Our Case Number: ACP-323742-25

Re: Proposed development comprises the development of an extension to the existing Burial Ground at Drumcliff Burial Ground located at the Townland of Drumcliff, Ennis, Co. Clare
Drumcliff, Ennis, Co. Clare

Submission on s.177AE application JP03.323742 for proposed development comprises the development of an extension to the existing Burial Ground at Drumcliff Burial Ground located at the Townland of Drumcliff, Ennis, Co. Clare.

Map of traced conduit.

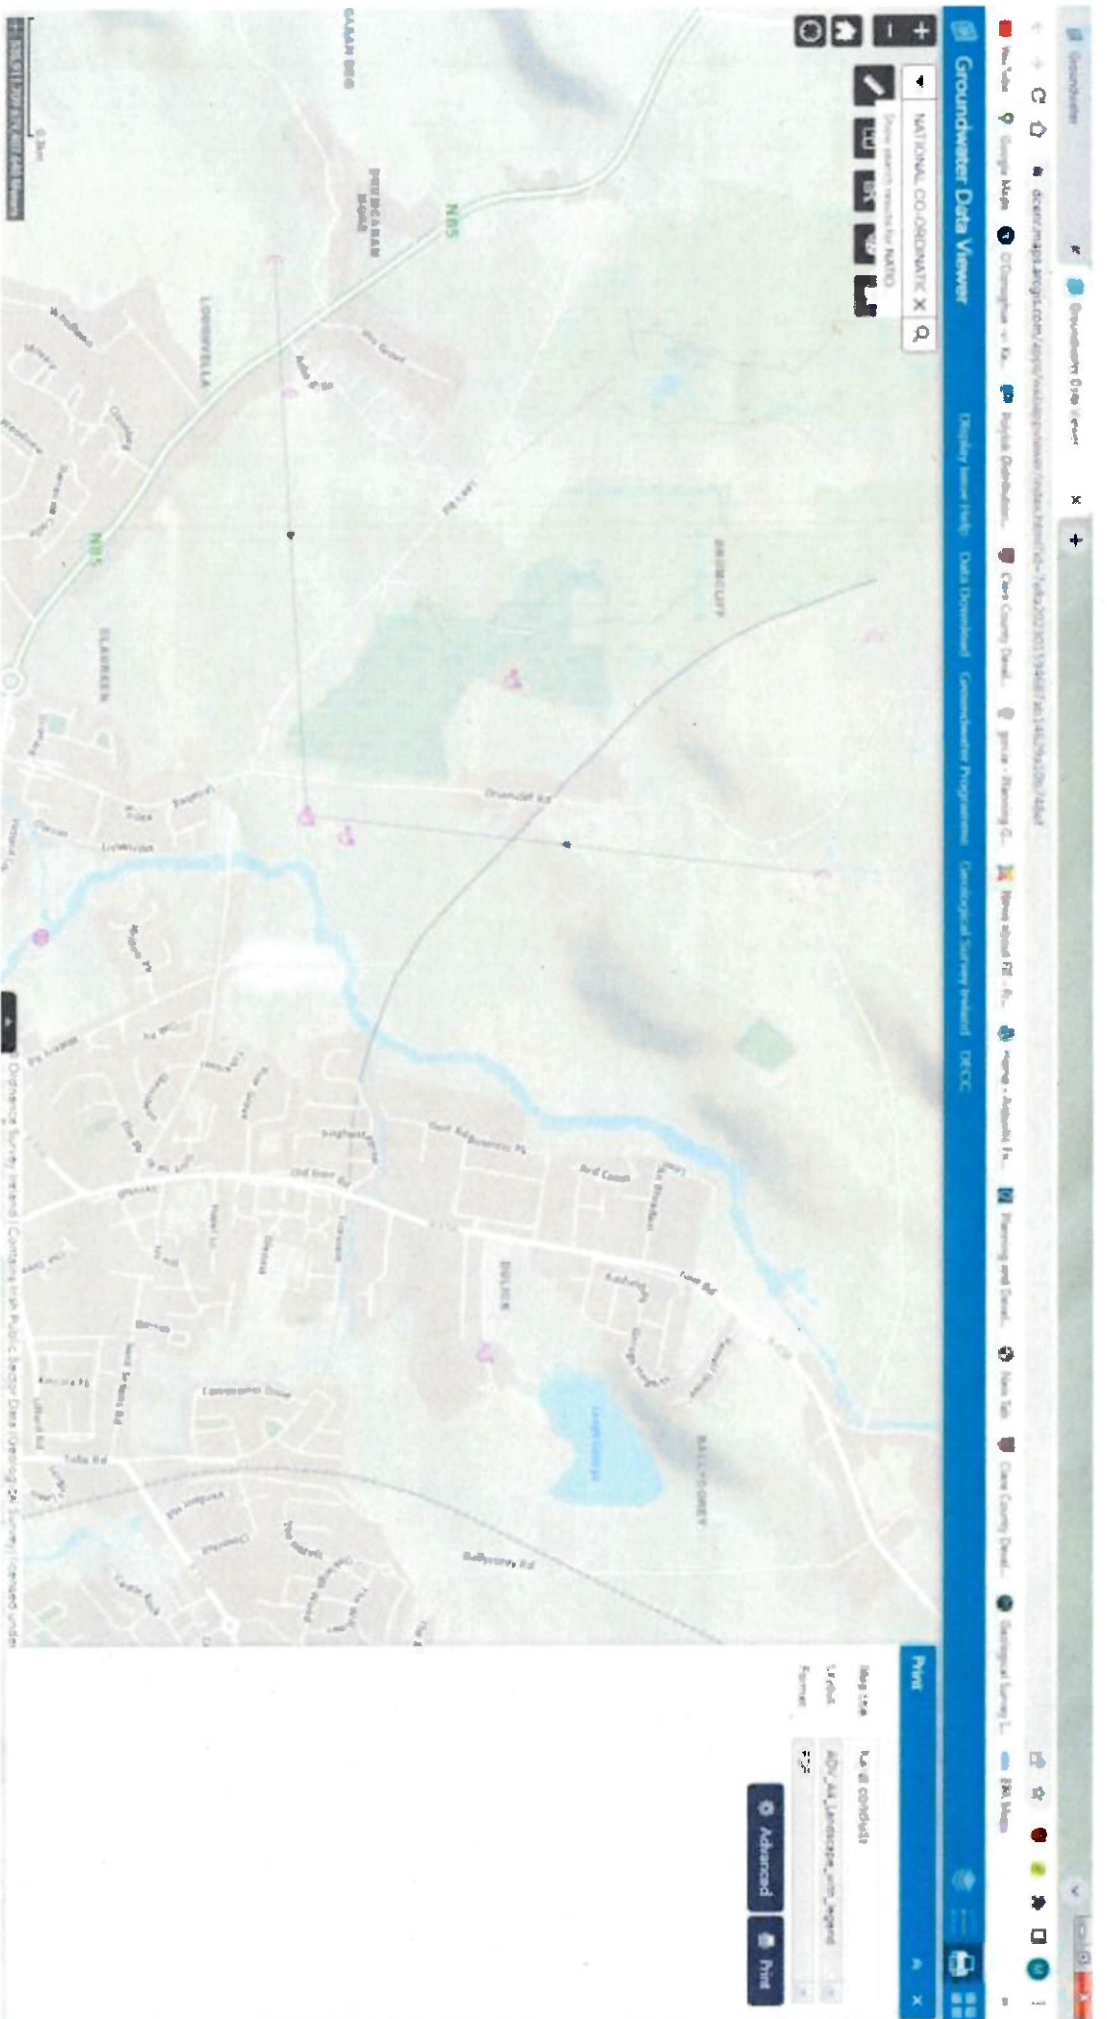
Yours faithfully,

10. There is no recognition of the karst conduit between Poulacorey swallow hole is connected to the Drumcliff Spring. This completely ignores the vertical separation to the conduit which is likely to be less than 10m as opposed to the 250m requirement. There is no geological testing of this site and therefore there is a lacuna in the information provided to the decision maker.

Karst conduit directly beneath subject site for development with direct connectivity to Drumcliff Spring
